New Gasliter Mark 10DN-117-3-15-15-P0062

Channel Products

Connection diagram for replacement gasliter

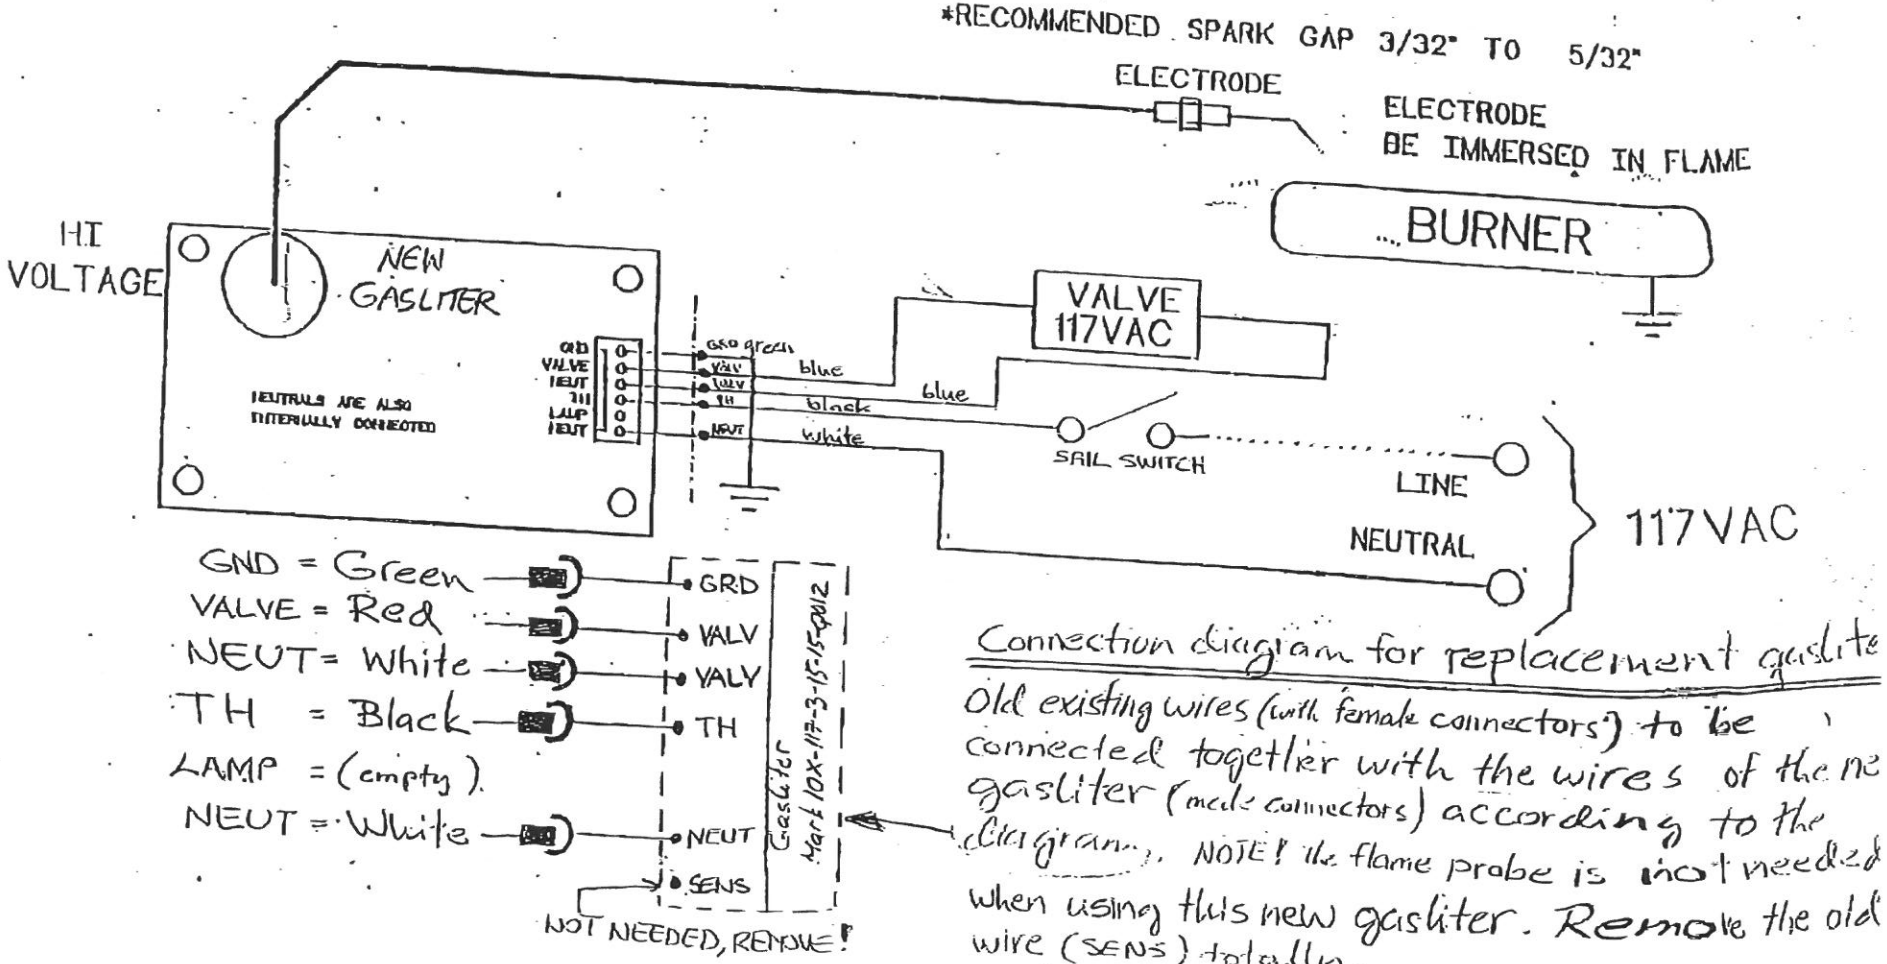
Old existing wires (with female connectors) to be connected together with the wires of the new gasliter (male connectors) according to the diagram. NOTE! the flame probe is not needed when using this new gasliter. Remove the old wire (SENS) totally.
